UNITED STATES PATENT AND TRADEMARK OFFICE

APPLICATION NO.	FILING DATE	FIRST NAMED INVENTOR	ATTORNEY DOCKET NO.	CONFIRMATION NO.
10/602,522	06/24/2003	James Yi	K0347.10U	2196
29633	7590	08/11/2006	EXAMINER	
ROGERS TOWERS, P.A. 1301 RIVERPLACE BOULEVARD, SUITE 1500 JACKSONVILLE, FL 32207			COMSTOCK, DAVID C	
			ART UNIT	PAPER NUMBER
			3733

Office Action Summary

DETAILED ACTION

Figure A

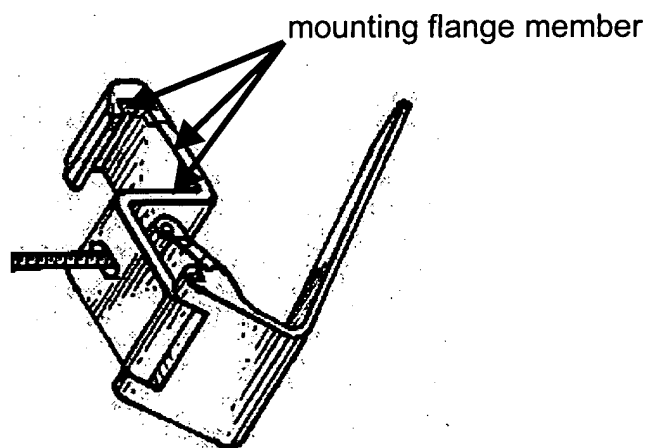
Koros et al. disclose a retractor device comprising a main body 28 having a generally C-shaped configuration comprising a foot member 54, an elevation wall member 44, 46, a mounting flange member, and a pair of extended hook members 38 mounted to the flange member (see Figures 1 and 5 and supplemental Figure A below).

Figure B

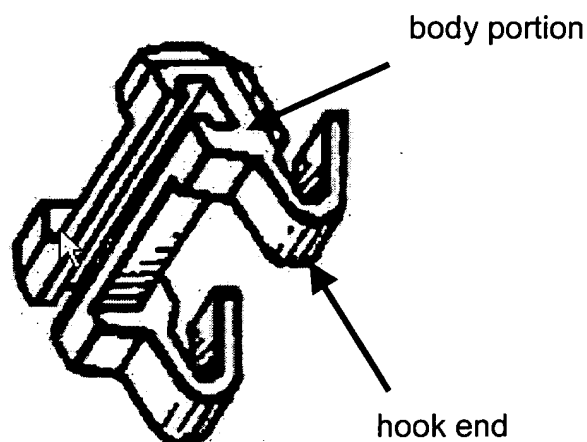
The elevation wall member 44, 46 comprises an upper wall member 44 joined to a lower wall member 46 along a radiused junction (see Figs. 5 and 7). The lower wall member is joined to the foot member and the upper wall member is joined to the flange member. The pair of extended hook members each comprise a hook end and a body portion (see, e.g., Fig. 5 and supplemental Figure B below).
